**Project: South Battery Park City Resiliency Project:  
Pier A Plaza / Battery Site Work And Near  
Surface Isolation (“NSI”) Construction Services  
Request for Proposals (“RFP”)**

**Date: February 2, 2023**

**RE: Addendum #7  
# of Pages: 85**

L-936.00

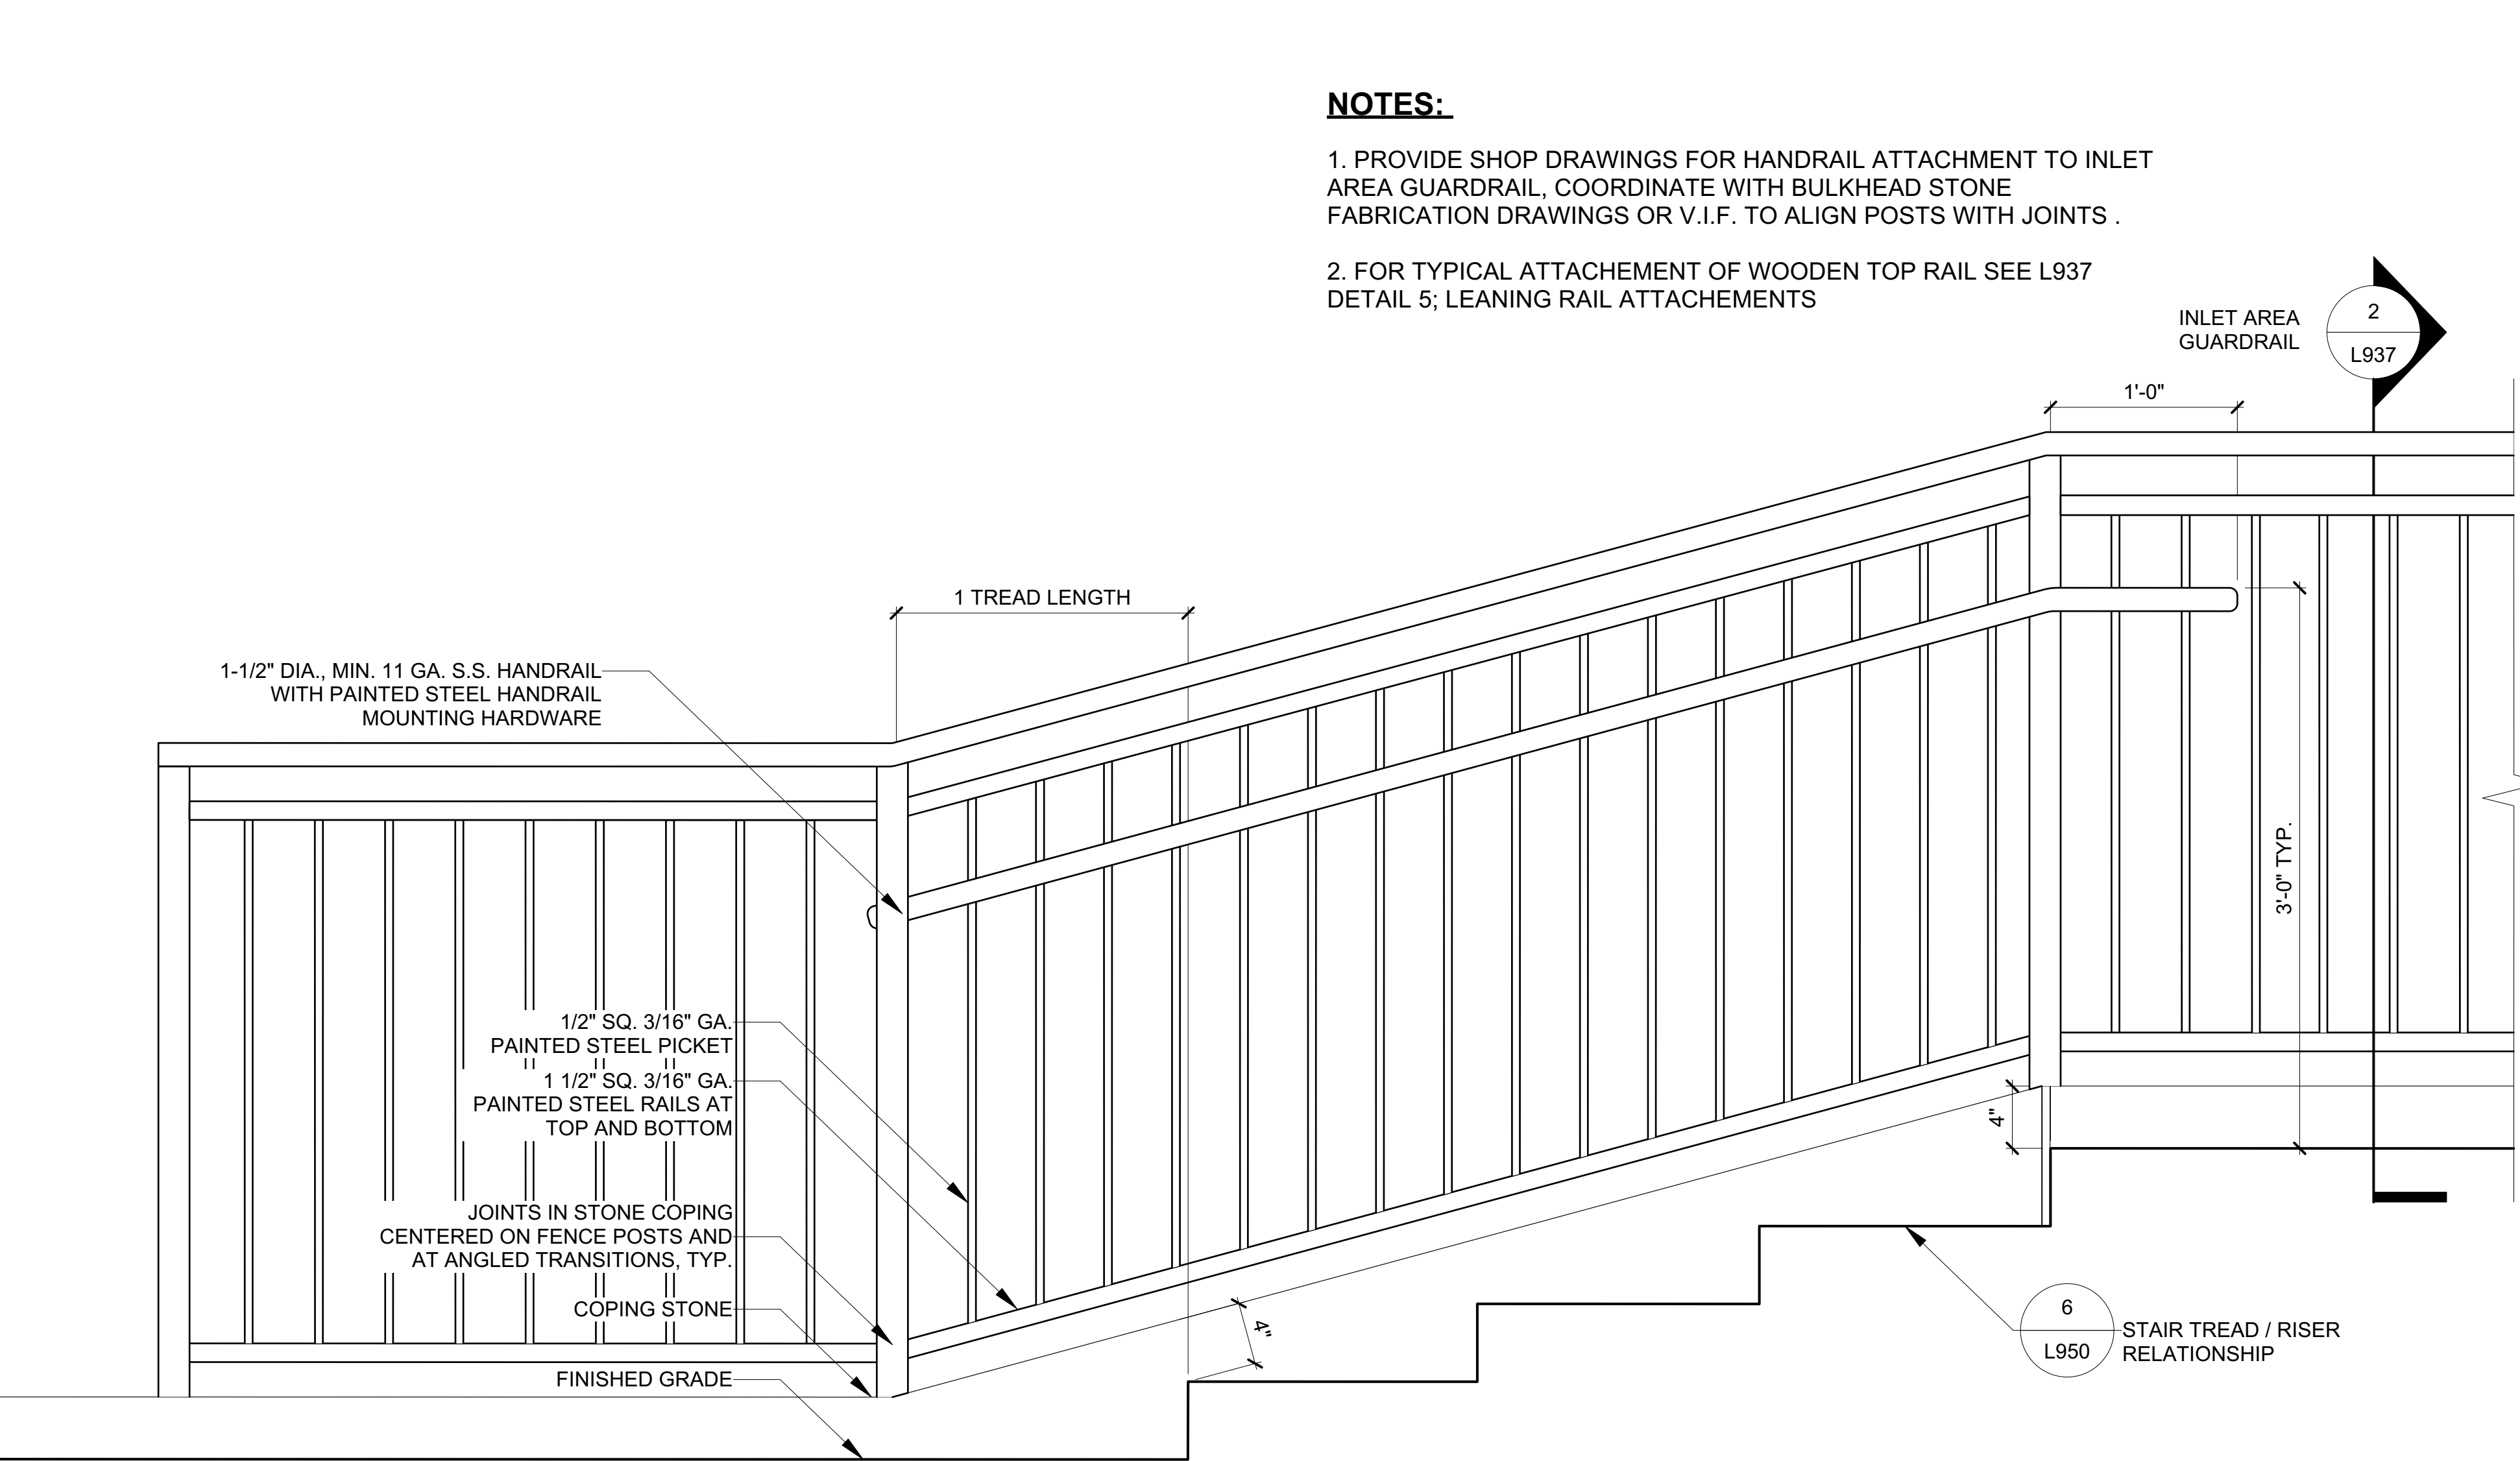
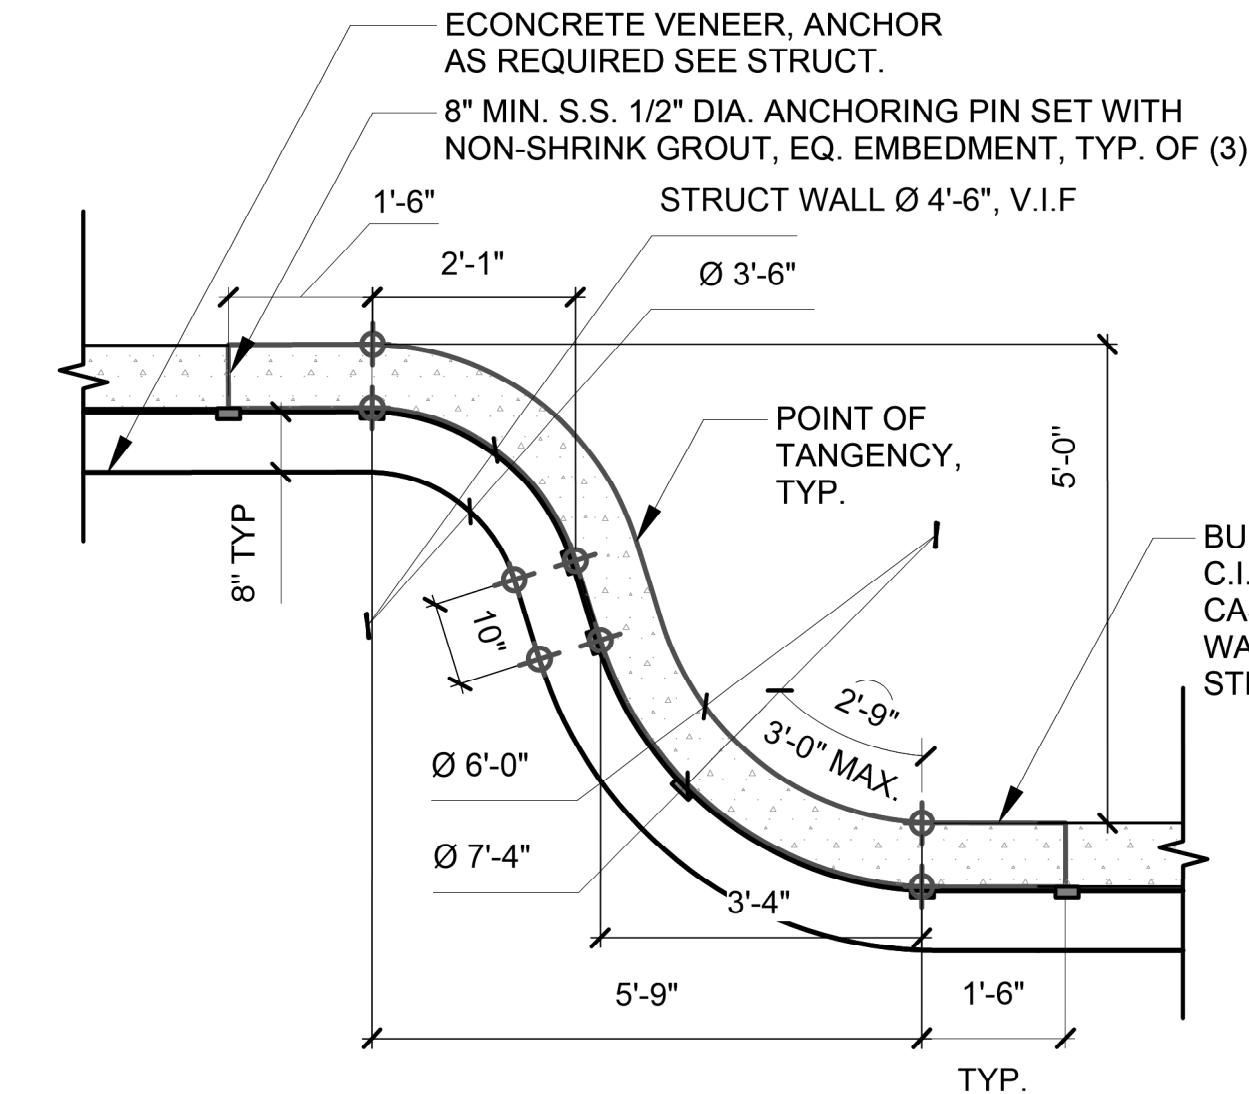
- 17) Reference Sheet L-301A.00: The 51’ LF Guardrail labeled as INLET AREA GUARDRAIL in the legend notes is called out as PLAZA AREA GUARDRAIL and refers to details: 2/L937 PLAZA AREA GUARDRAIL and All/L936. Please confirm if this 51’ LF guardrail is identified as the inlet area guardrail or the plaza area guardrail? Additionally, please clarify what specific detail and drawing we should refer to?

***The guardrail labeled as 2/L937 PLAZA AREA GUARDRAIL and ALL/L936 has been corrected to 1/L936 POST LAYOUT AT INLET AREA GUARDRAIL - ELEVATION. Additional callouts labeled as 3/L935 PIER A INLET GUARDRAIL and 2/L936 INLET AREA GUARDRAIL TYPICAL HANDRAIL AT STAIRS - ELEVATION will be added to Detail 1/L936 to better differentiate multiple detail interfaces. As noted in Section A – REVISIONS TO RFP (above), revised versions of Drawings L301A and L936 are both provided a part of Attachment #1.***

**8 SALVAGED STONE FLUSH WITH PAVEMENT**  
SCALE: 1" = 1'-0"

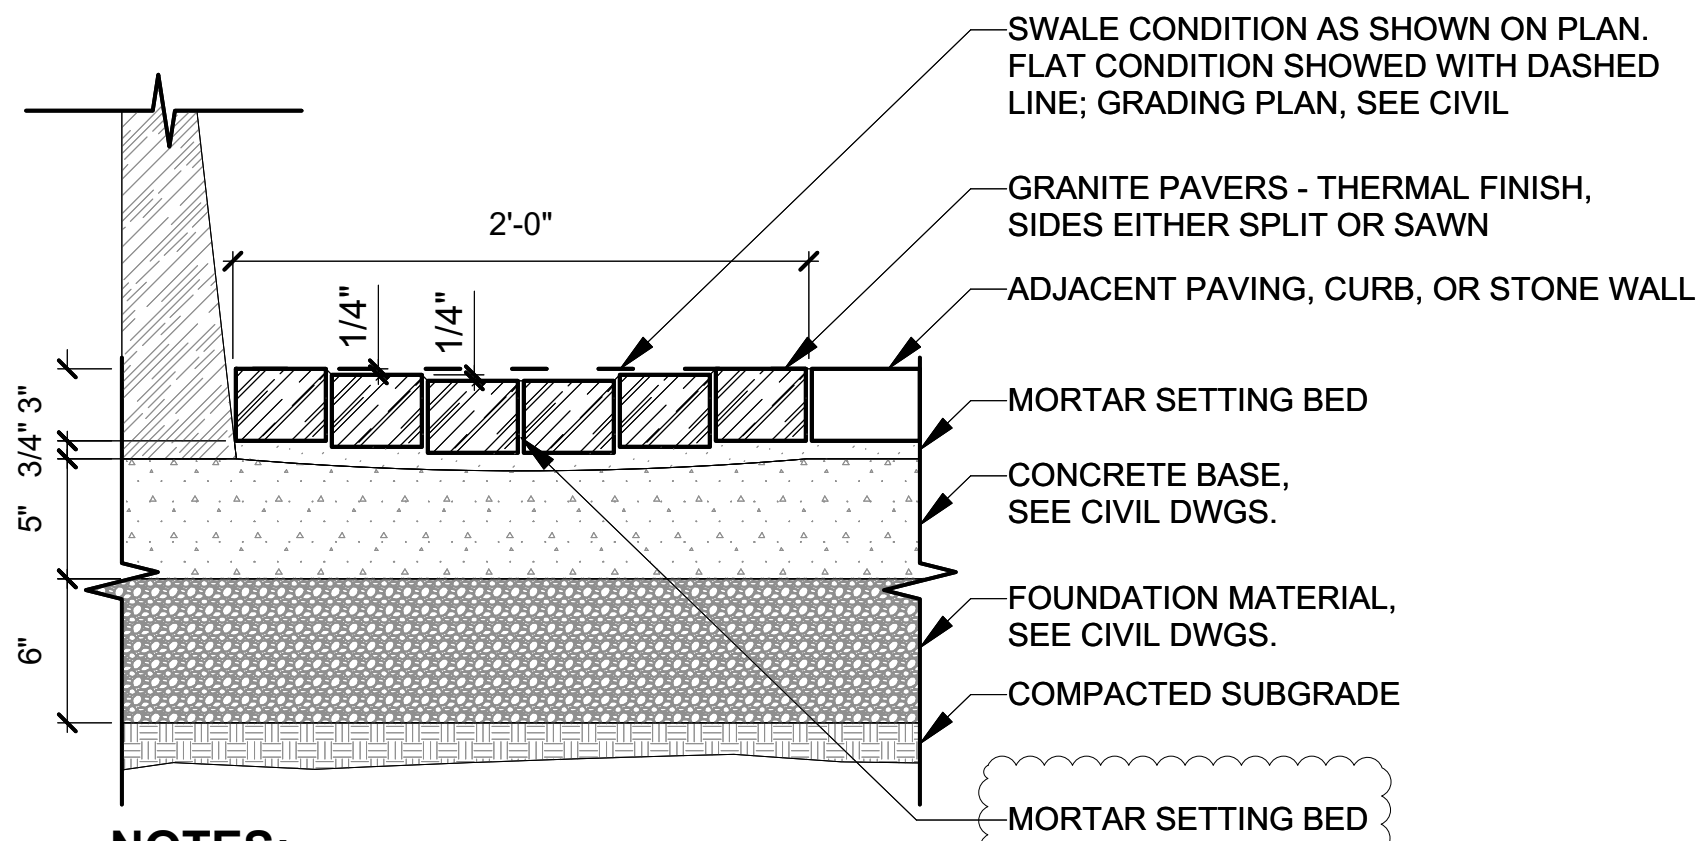
- 27) Drawings L-601 indicates hatched area as "Salvage Stone Pavement" and refers to detail 9/L962, however detail 9/L962 "Salvaged Stone Flush Pavement" is crossed out indicating "NIC". Please advise as to the Stone TYPE, Quarry, Thickness to replace existing damaged or new configured and required stone at Rector Park to allow for new CSO Chamber Manholes and construction.

***Field conditions related to the existing granite stone pavers at Rector Street have not been verified. The thickness of granite pavers should be verified in the field by the selected Proposer. The callout 9/L962 SALVAGE STONE PAVEMENT REPLACE IN KIND, MATCH ADJACENT PIECES, PATTERN AND FINISH on Drawing L601 has been revised to 7/L900 SITE SALVAGE GRANITE PAVING, REPLACE IN KIND, MATCH JOINING ADJACENT PIECES, PATTERN AND FINISH. A new detail for Site Salvage Granite Paving will be added to Drawing L900 as Detail 7/L-900. As noted in Section A – REVISIONS TO RFP (above), revised versions of Drawings L601 and L900 are both provided as part of Attachment #1.***
